DATE		23/05/06
DESIGN	DATE	
REVISION	DATE	
SAFETY CONTROL	DATE	
RELEASED	DATE	
SCALE		
DRAWING NO.		
REV		
COMPANY	VIDEOCON INTERNATIONAL LTD.	
ITEM	21TY LCD LOOK CHASSIS

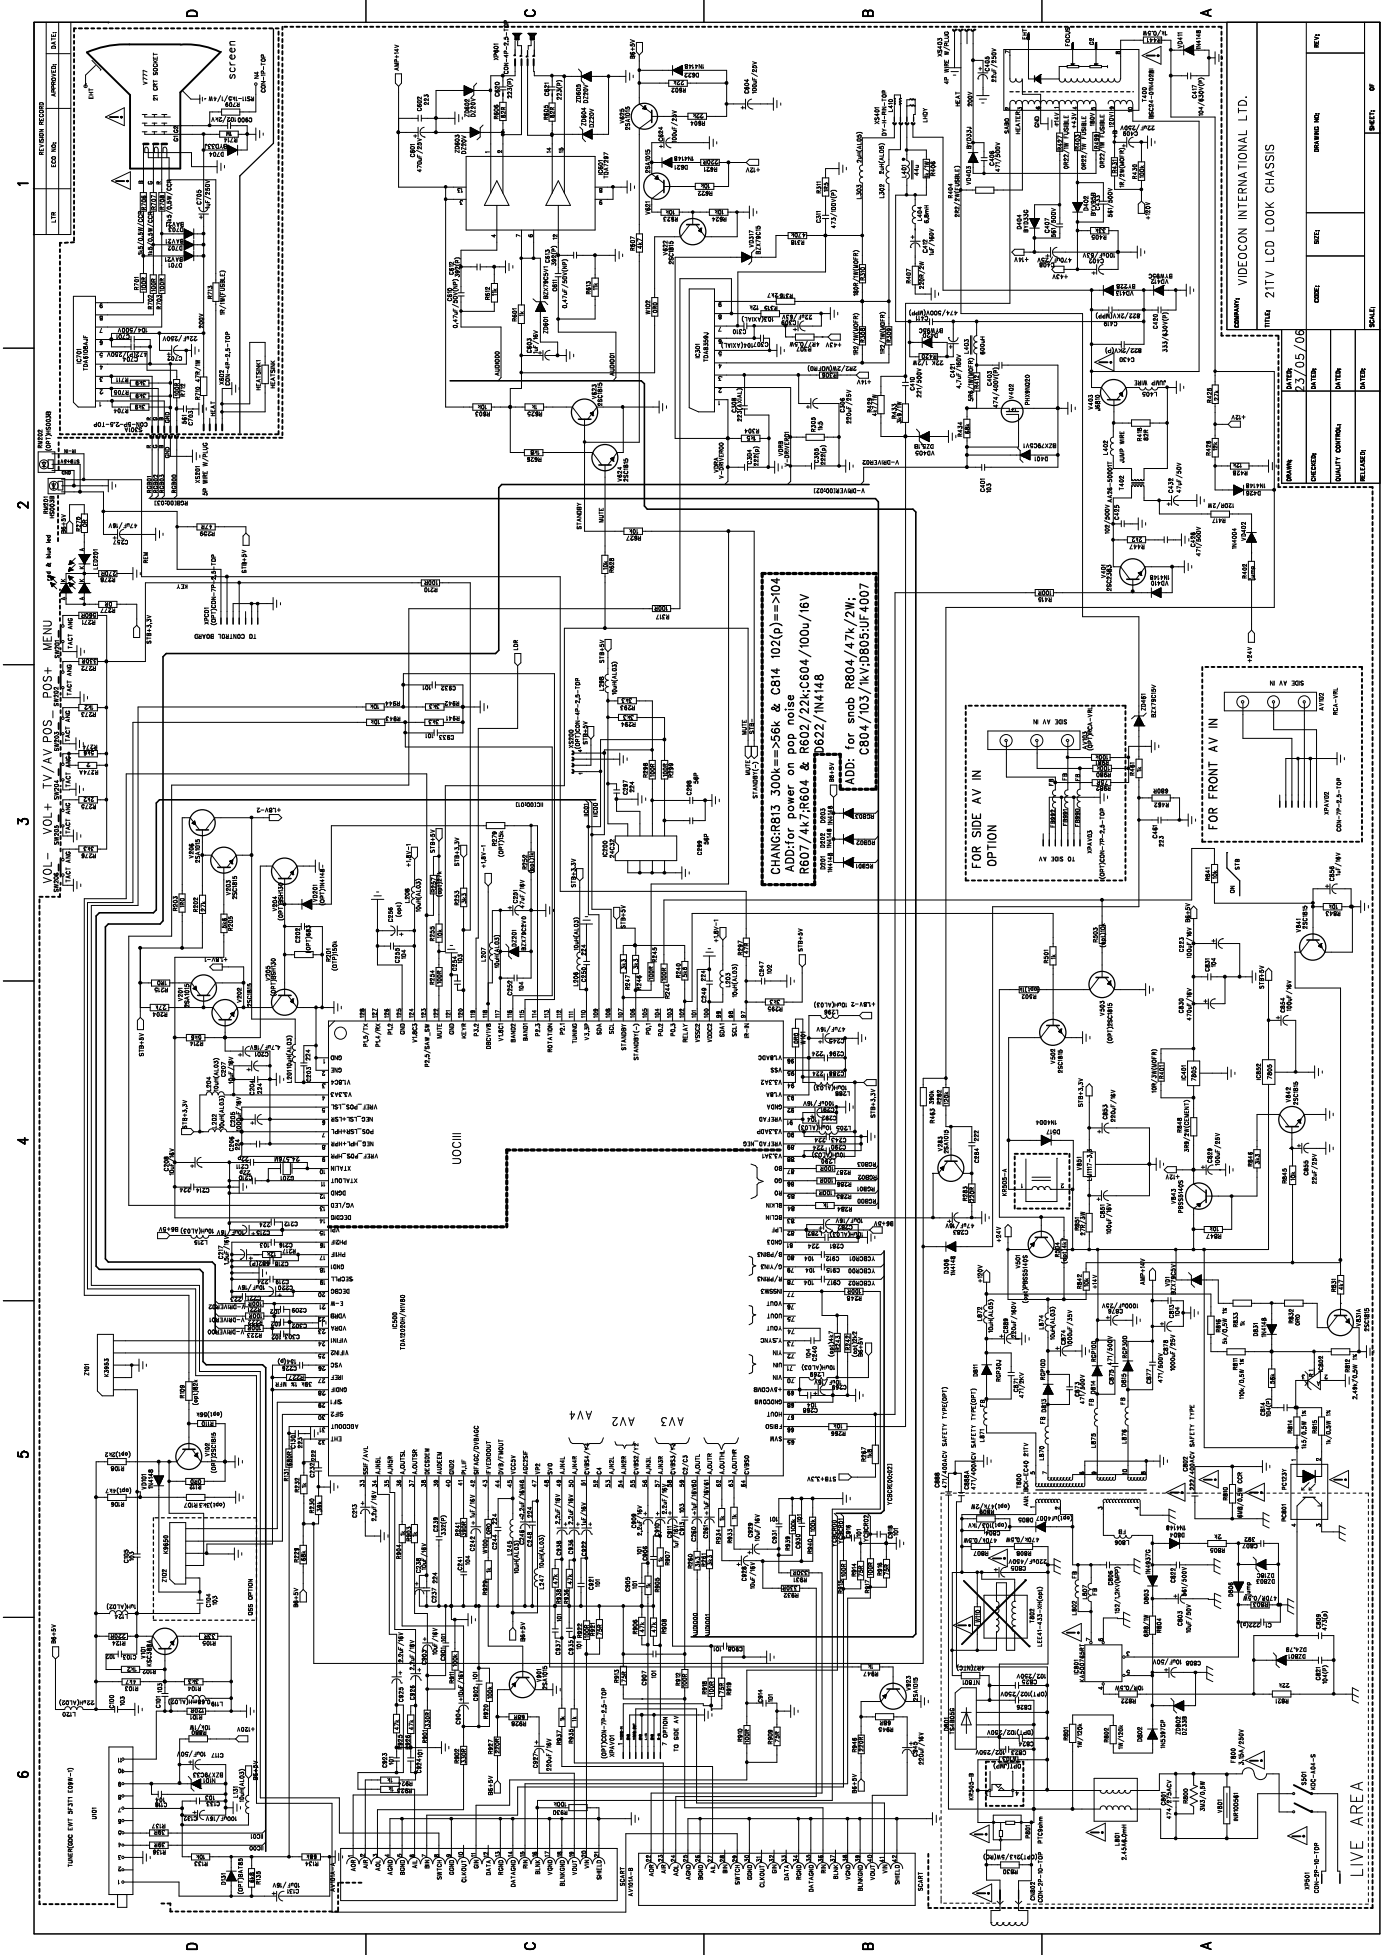
CHANG-RB13 300K => 26K & CB14 02(p) => 04
 Add: for resb R804/47K/2W;
 R807/44.7R04 & R807/22K; C804/100u/16V;
 R802/1M4148
 ADD: for resb R804/47K/2W;
 C804/103 1Kv/R805/JF L007

DATE		23/05/06
DESIGN	DATE	
REVISION	DATE	
SAFETY CONTROL	DATE	
RELEASED	DATE	
SCALE		
DRAWING NO.		
REV		
COMPANY	VIDEOCON INTERNATIONAL LTD.	
ITEM	21TY LCD LOOK CHASSIS

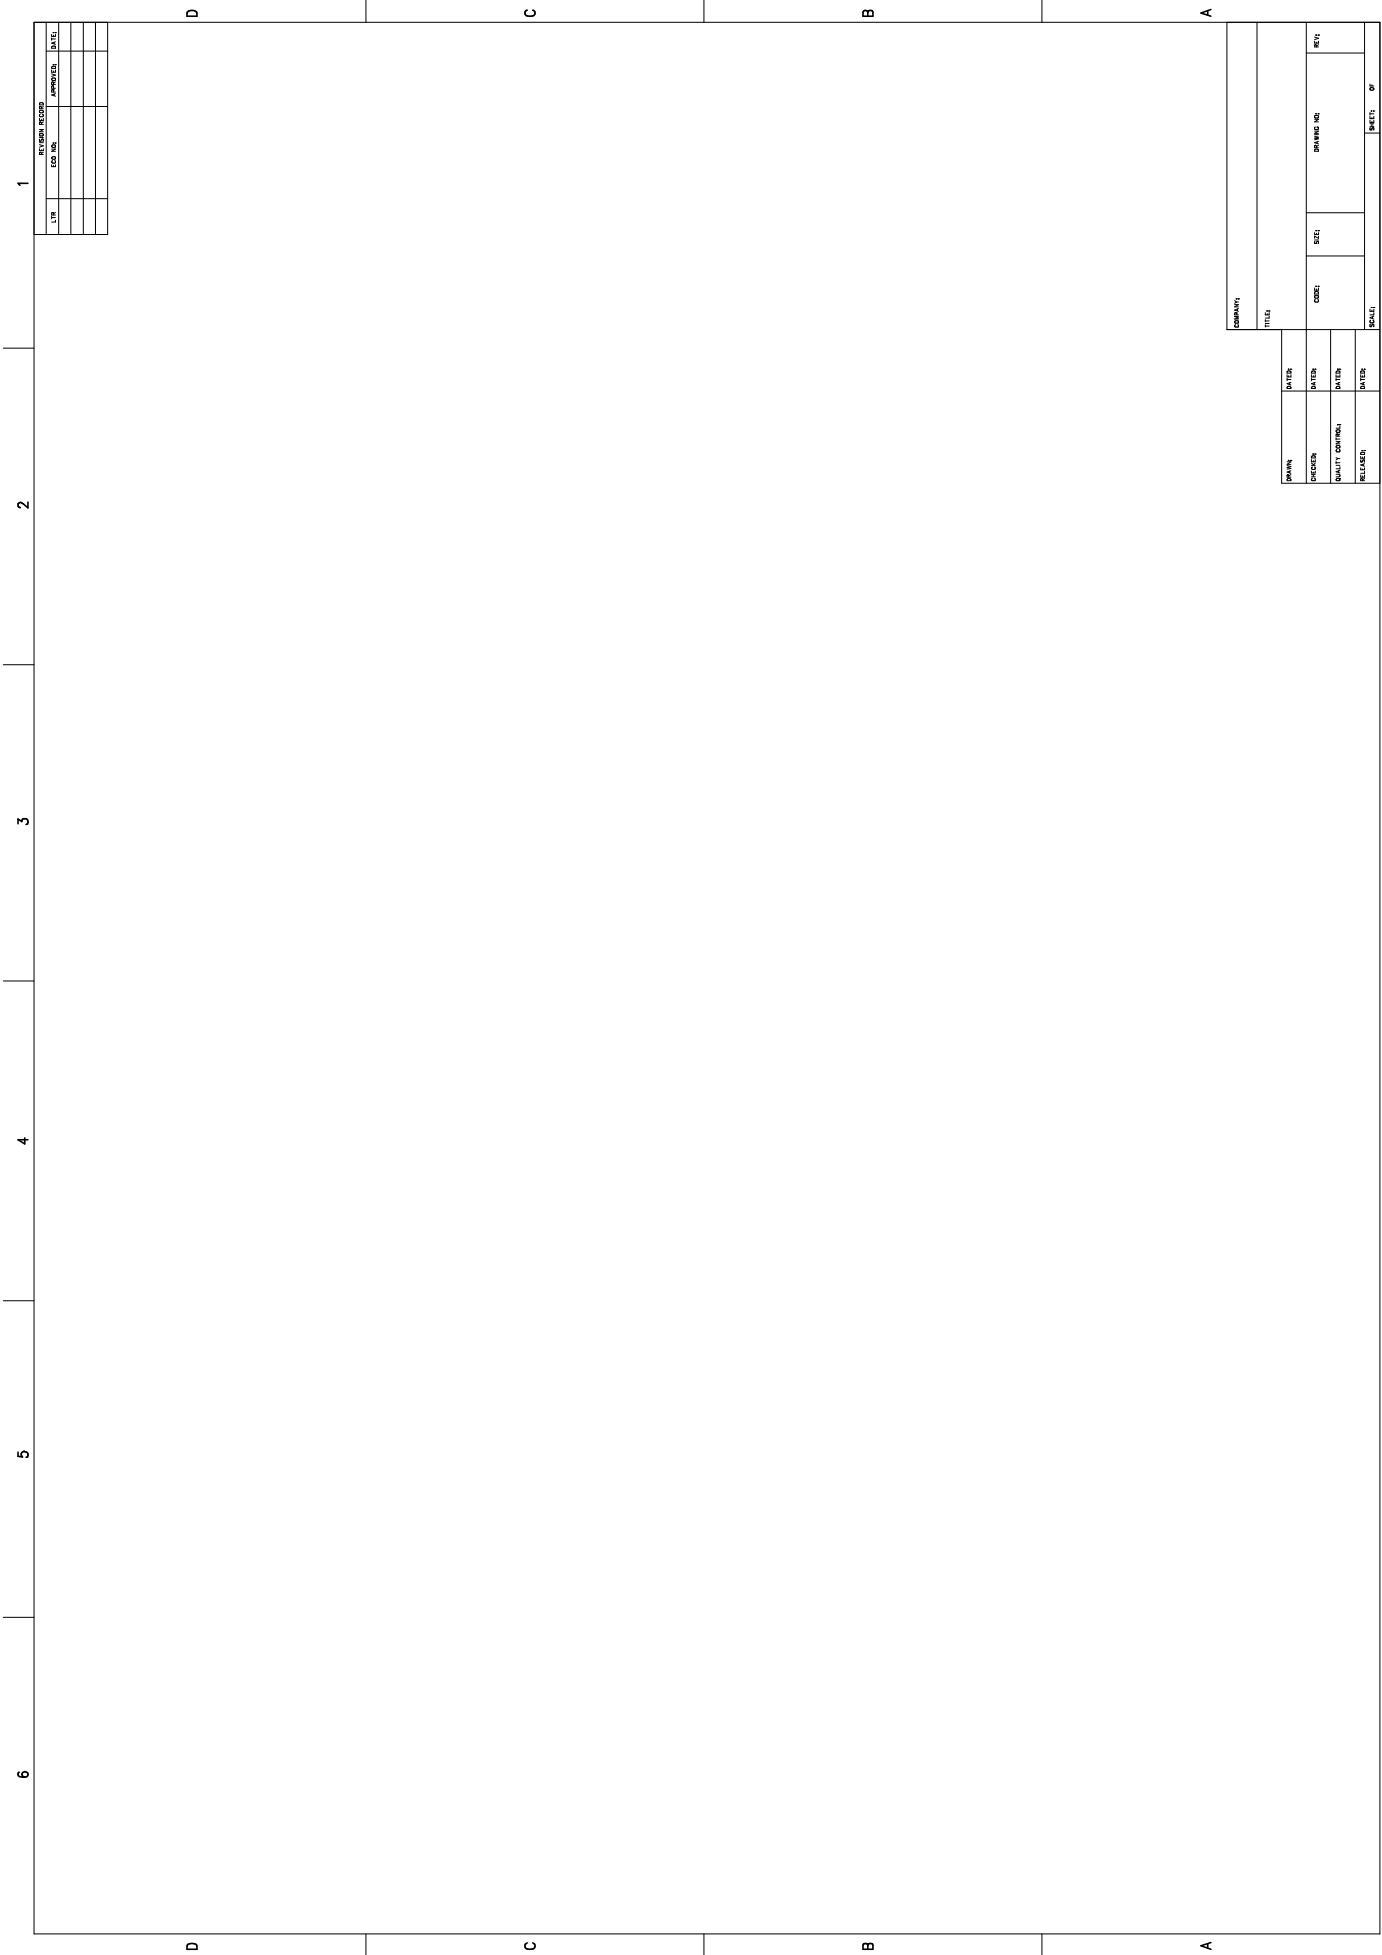
CHANG-RB13 300K => 26K & CB14 02(p) => 04
 Add: for resb R804/47K/2W;
 R807/44.7R04 & R807/22K; C804/100u/16V;
 R802/1M4148
 ADD: for resb R804/47K/2W;
 C804/103 1Kv/R805/JF L007
